UNITED STATES OF AMERICA
NUCLEAR REGULATORY COMMISSION

In the Matter of
THE REGENTS OF THE UNIVERSITY
OF CALIFORNIA
(UCLA Research Reactor)

Docket No. 50-142

DECLARATION OF DAVID R. DUPONT

Temperature of Irradiation vs k (rate constant)

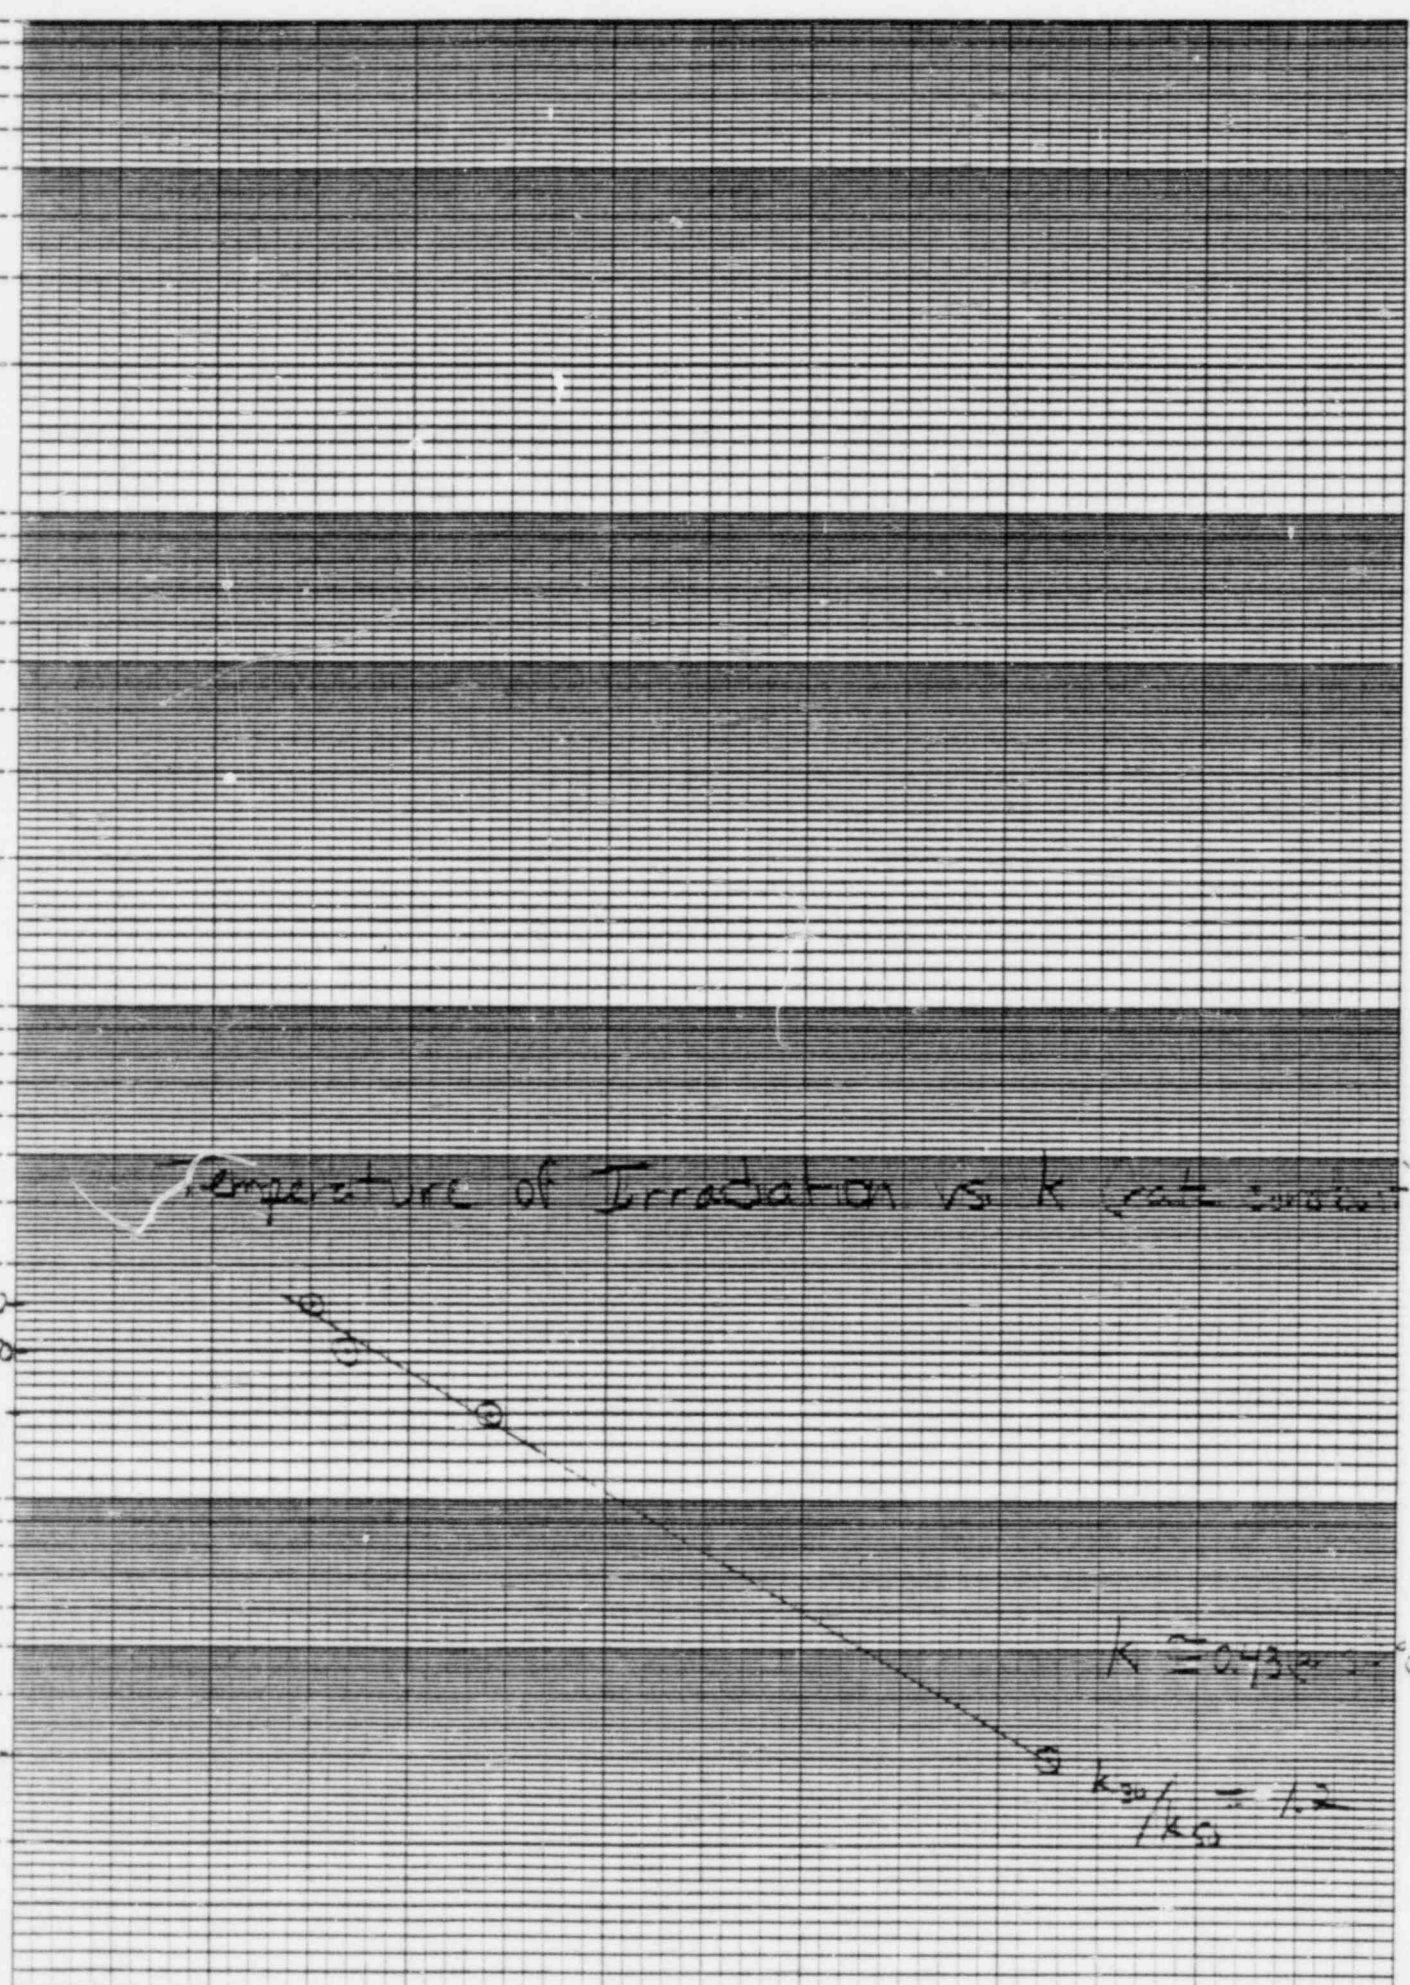
16. In order to correct these rates for the somewhat higher temperature found in the Argonaut's graphite, cited to be approximately 50°C, Hawley uses a correction factor of 3/5ths. Data given by Nightingale (p. 328) for the change in the rate of energy storage with temperature, however, when graphed (see attachment) produce an actual ratio of 5/6ths (inverse 1.2). This yields storage rates of .5 to .83 cal/g per MWd/At at 50°C, as opposed to the .3 assumed in the Hawley report at this stage of the calculation.
